IVECO Eurocargo MY2024

SB24100069 // ZF 8-speed automatic transmission

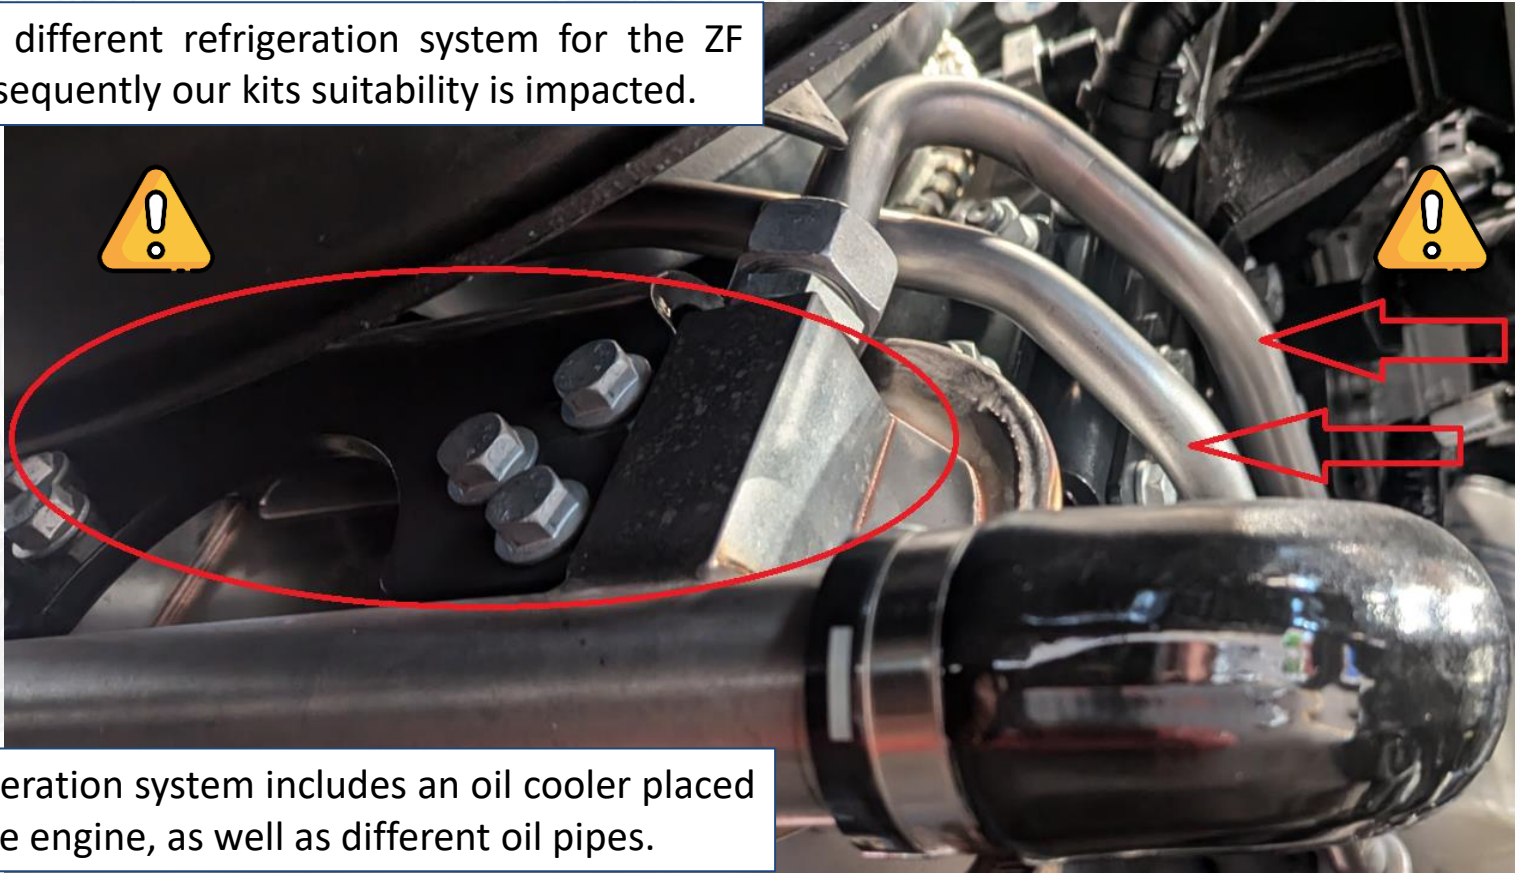
The current kits are **NOT SUITABLE** for trucks equipped with **8-SPEED ZF AUTOMATIC GEAR BOX.**

Iveco launched a different refrigeration system for the ZF gear box, and consequently our kits suitability is impacted.

The new ZF refrigeration system includes an oil cooler placed on the front of the engine, as well as different oil pipes.
